# DANE COUNTY DEPARTMENT of PUBLIC WORKS, HIGHWAY and TRANSPORTATION

**ATTENTION ALL REQUEST FOR PROPOSAL (RFP) HOLDERS**  
**RFP NO. 317025 - ADDENDUM NO. 1**  
**PROFESSIONAL ENGINEERING SERVICES FOR BIOGAS FACILITY**  
**DANE COUNTY LANDFILL SITE #2**  
**7102 U.S. HIGHWAY 12 & 18**  
**MADISON, WISCONSIN**

**FIGURE 1. SITE MAP (ADDENDUM NO. 1)**

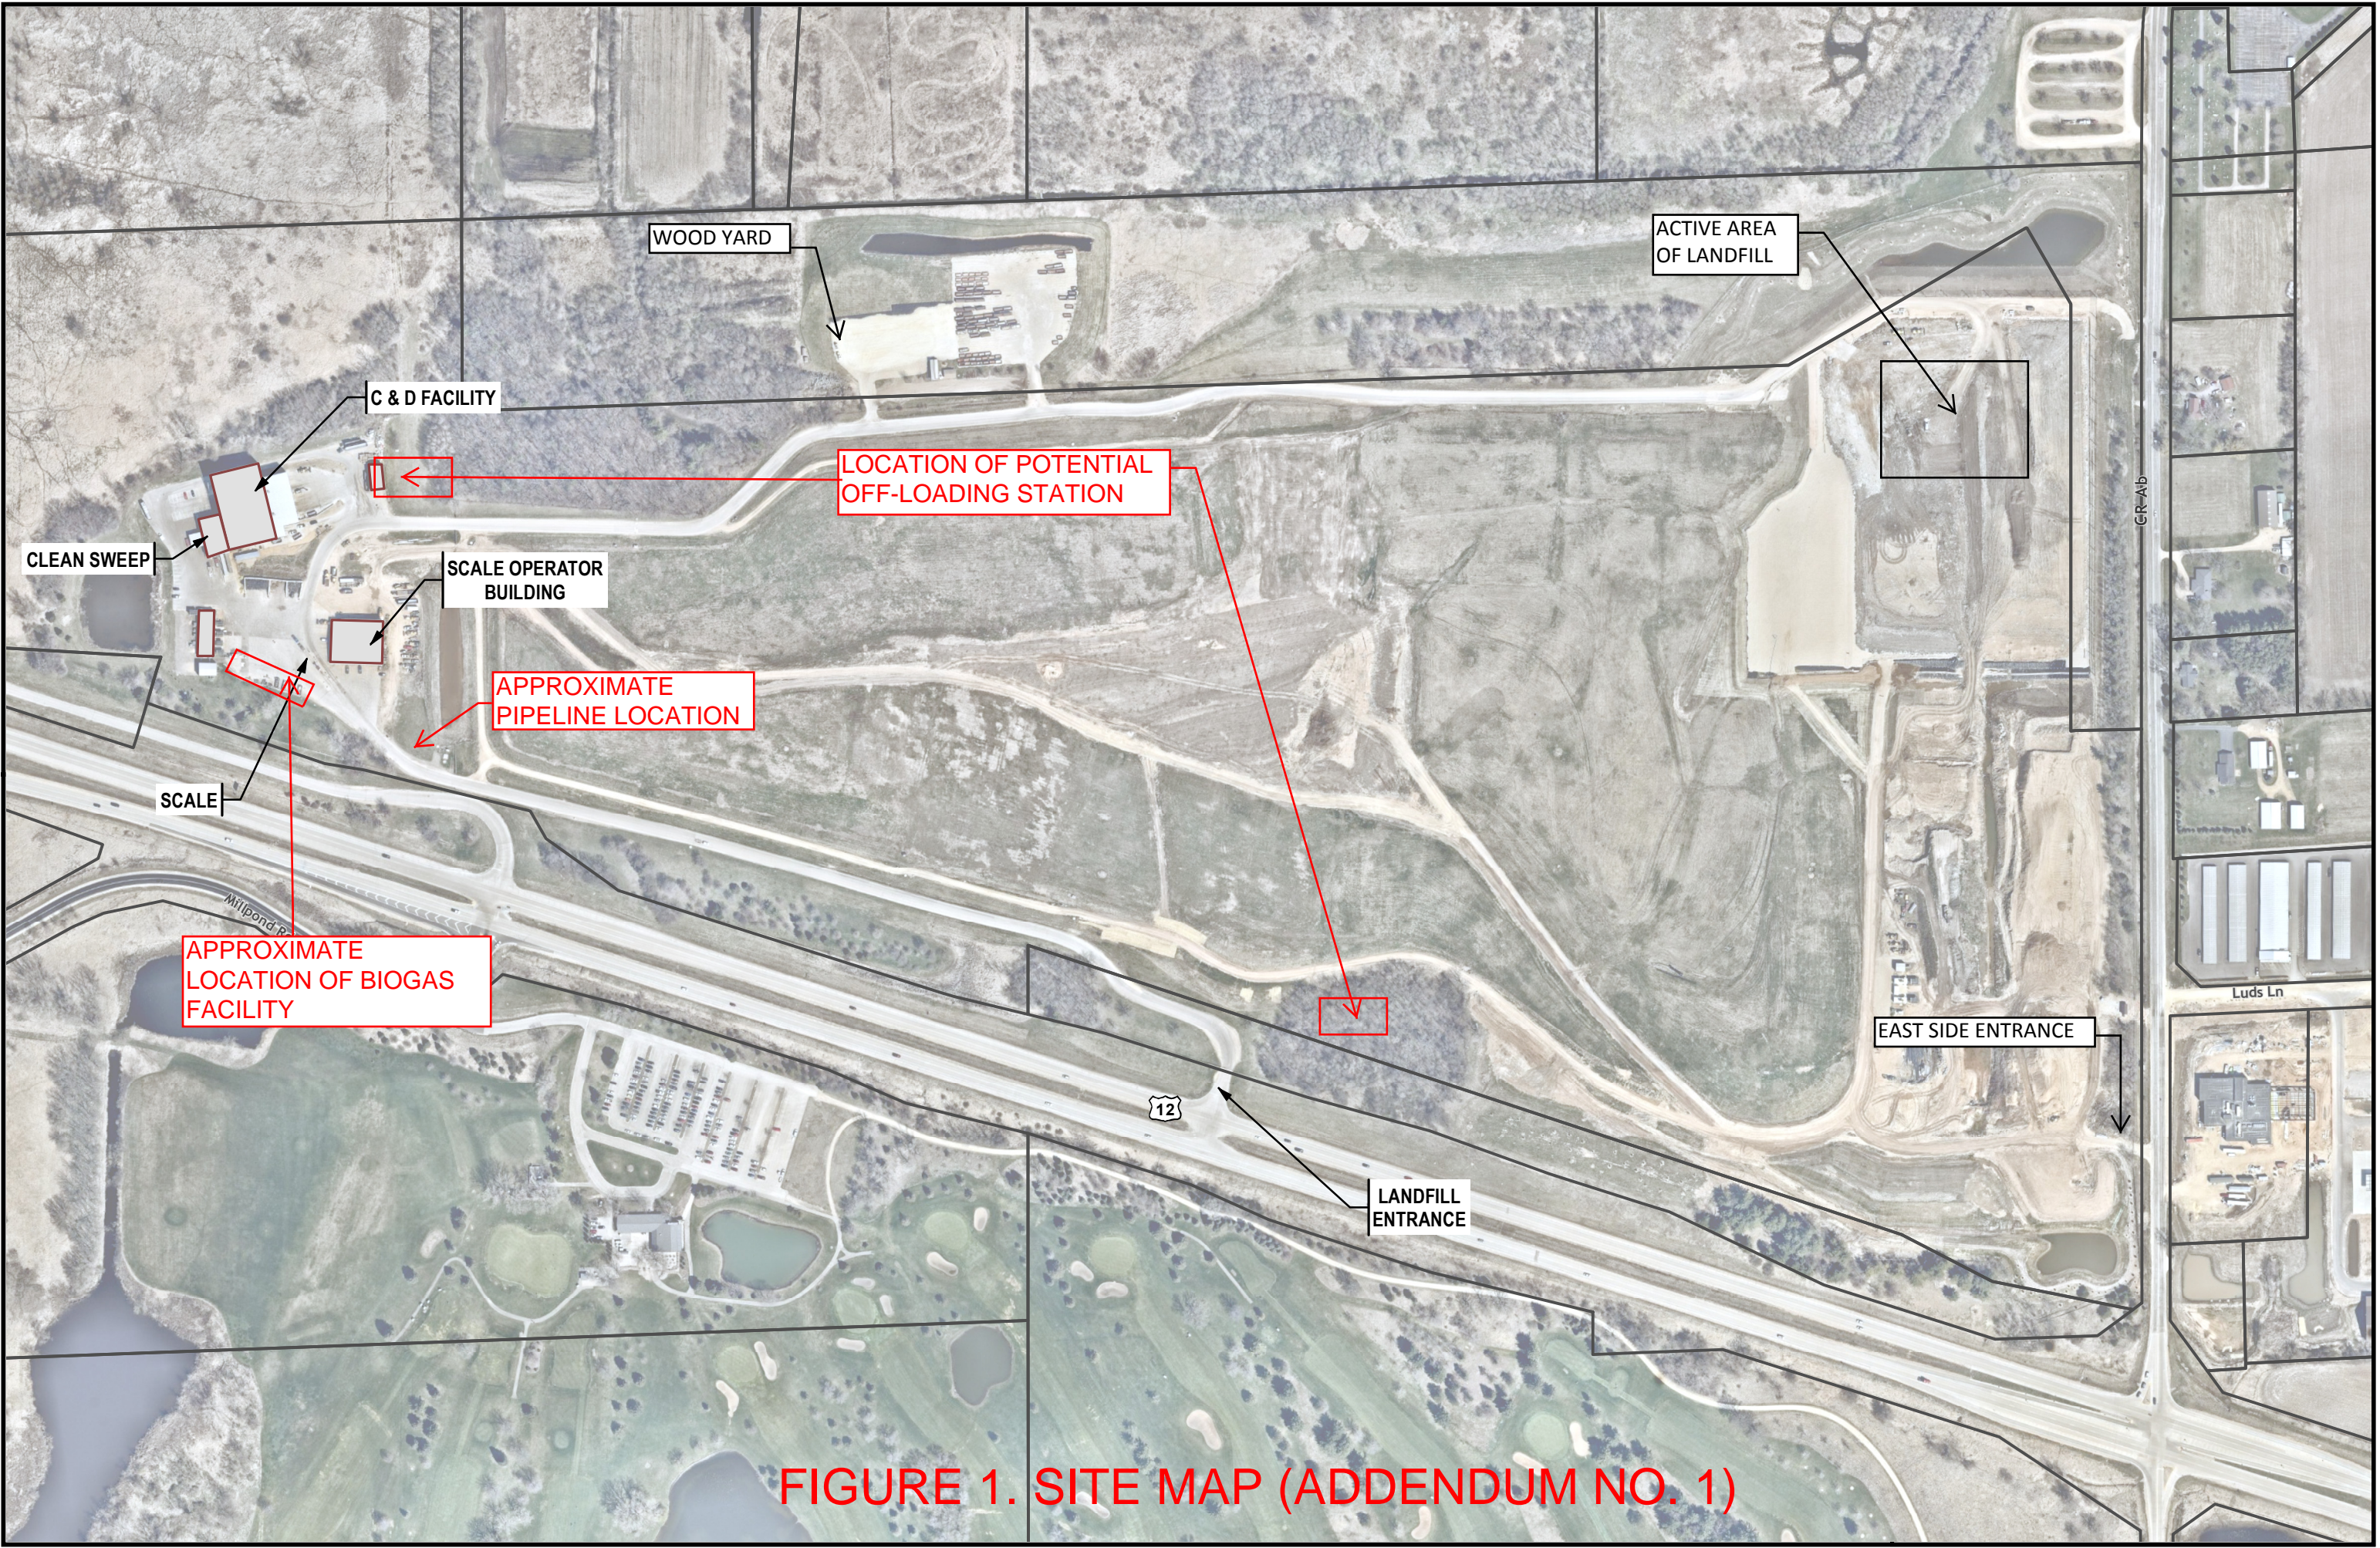
Remove Figure 1; replace with new Figure 1, issued with this Addendum. The revised figure is marked “Addendum No. 1”. The new figure has been revised as follows:

Included potential locations for off-loading station for additional biogas sources. Dane County will entertain alternate locations.
